# PORT OF OAKLAND

**Subject:** *Response to Comments Regarding Work Plan for Additional Site Investigation Activities at 801 Maritime Street, Oakland, CA 94607*

Subject: Response to Comments  
Regarding 801 Maritime Street  
Oakland, California

**FIGURE 2**  
**POTENTIOMETRIC GROUNDWATER ELEVATION CONTOUR MAP**  
**DECEMBER 7, 1993**  
 FORMER MOBIL OIL BULK PLANT  
 PORT OF OAKLAND  
 OAKLAND, CALIFORNIA  
 PROJECT NO. 10-098

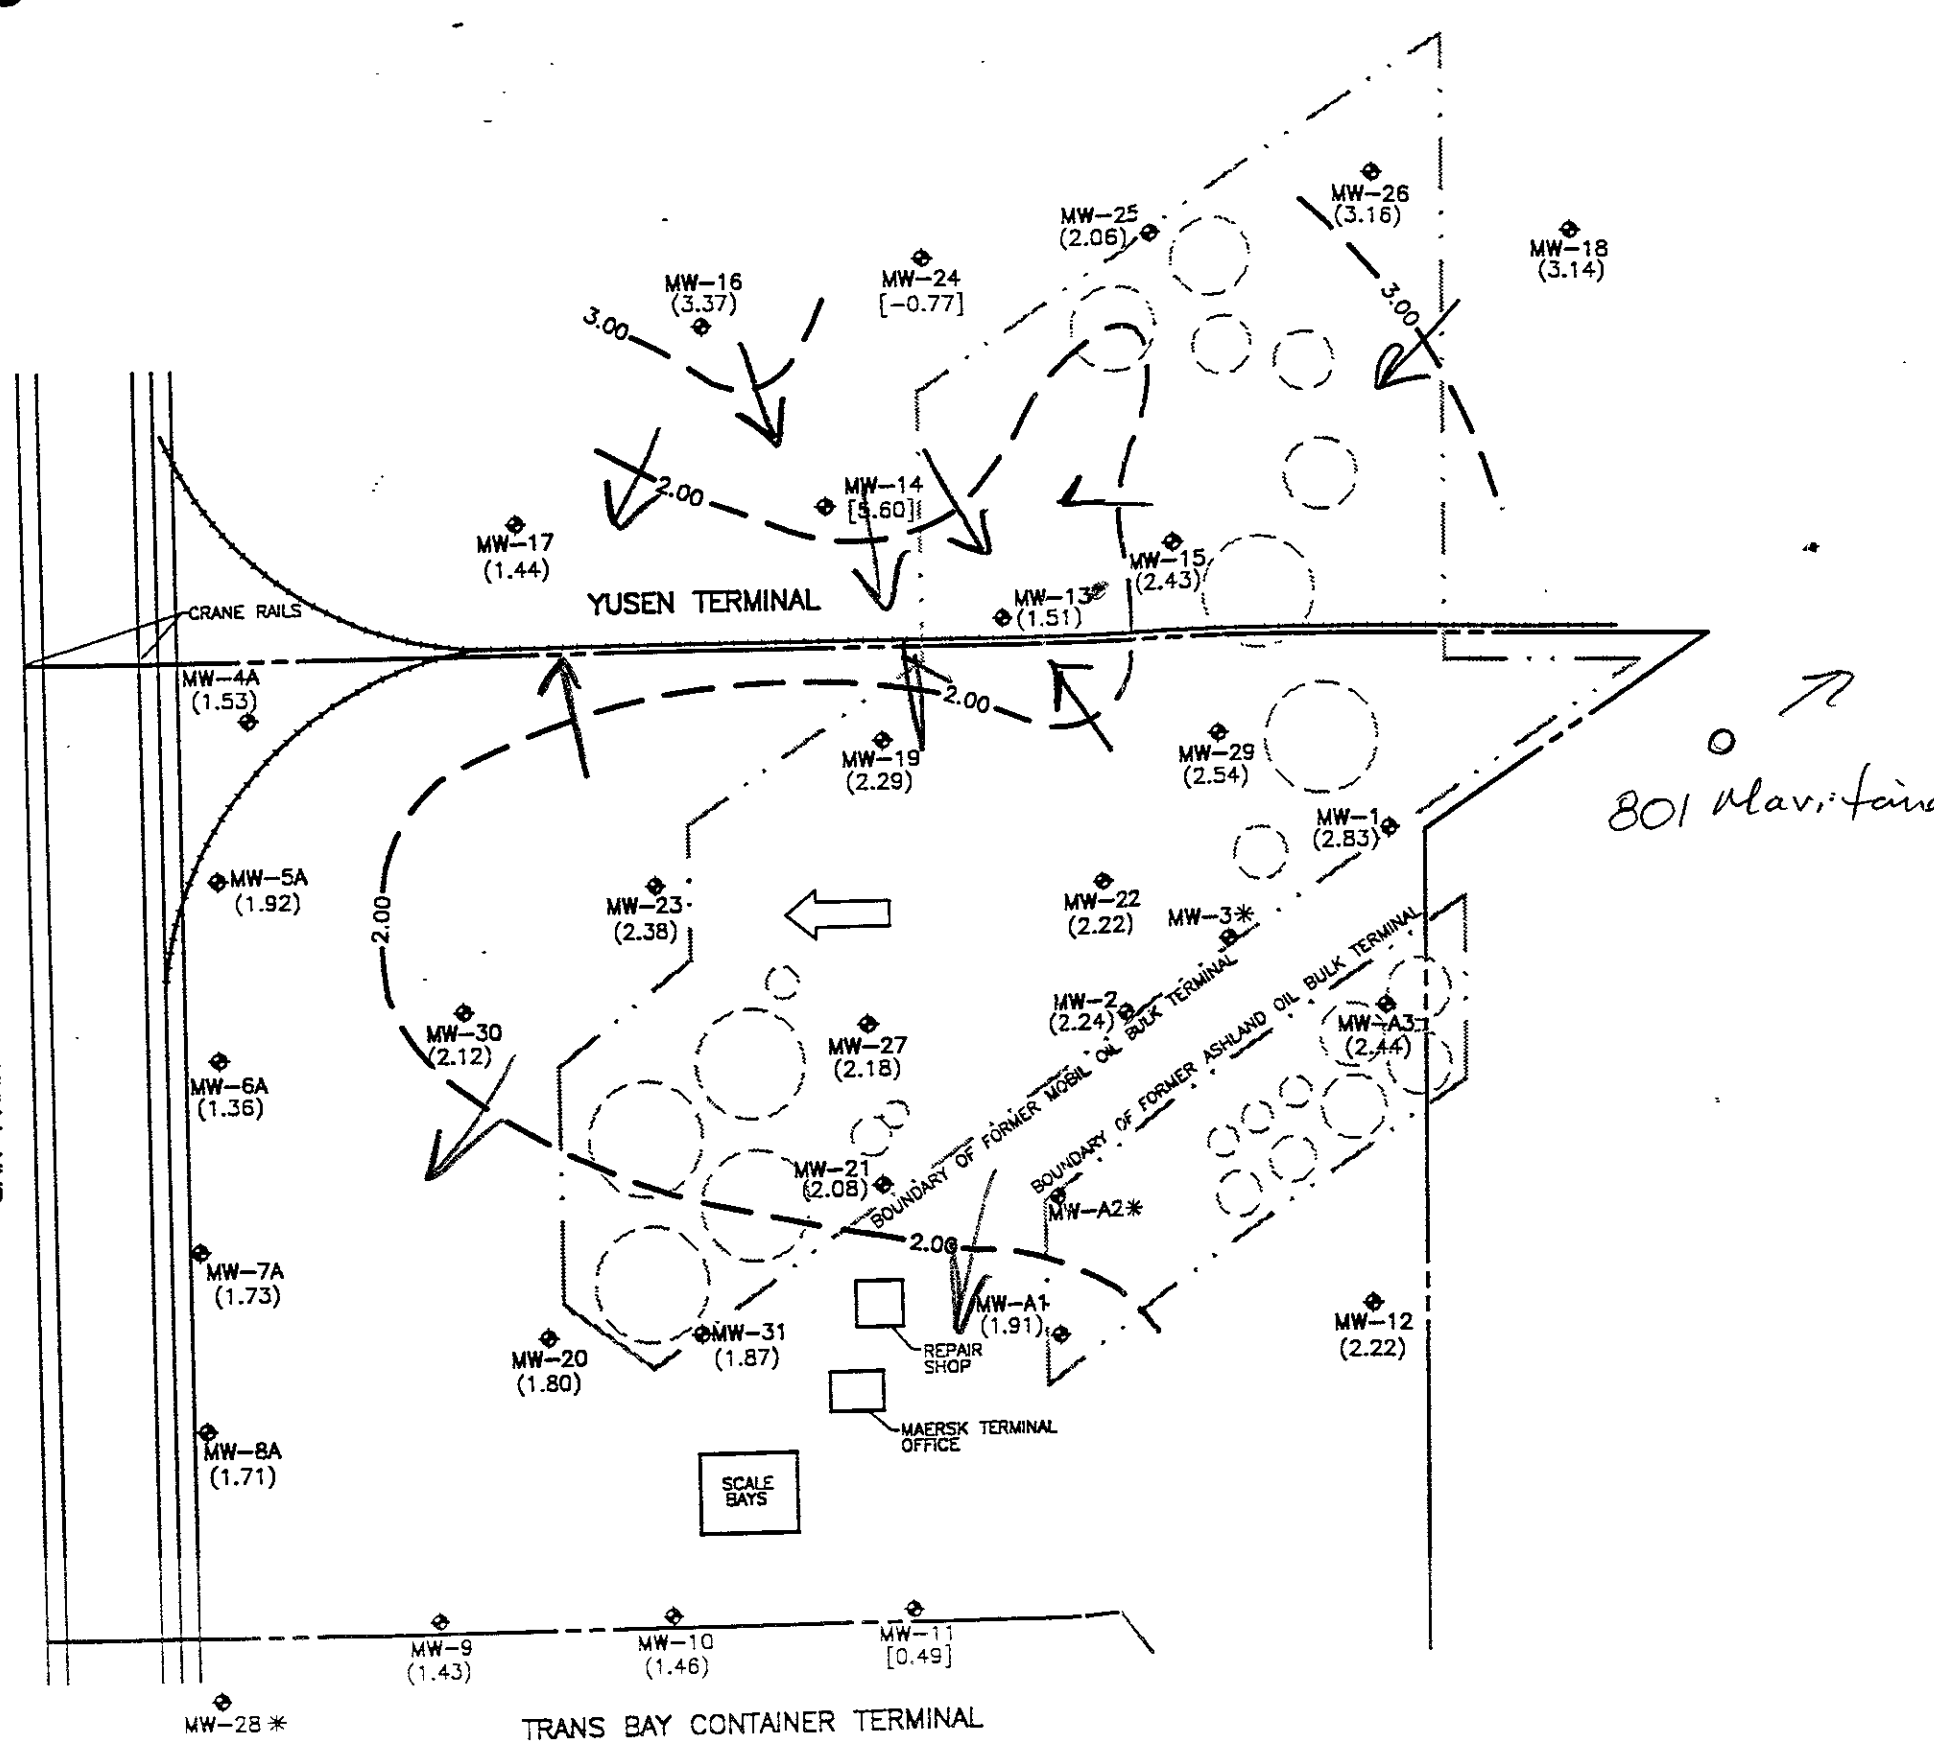
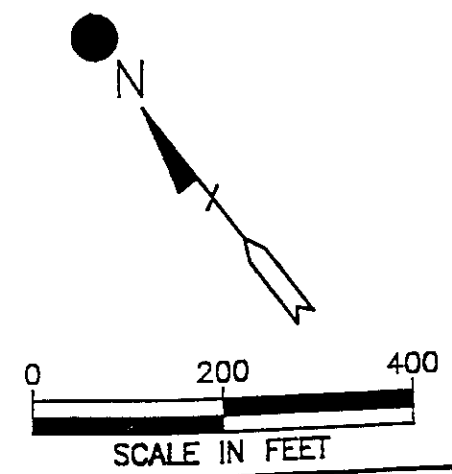
*3) Please specify what the groundwater direction at the Mobile site is, in terms of N, S, E, and W. The past two quarterly reports indicate a variable flow direction (Alisto, April and January 1994) (page 3).*

The overall groundwater flow direction is from the land toward the outer harbor. The groundwater maps show, however, variability due to tidal influence from the harbor that lies adjacent to the Mobil Oil site. *ok*
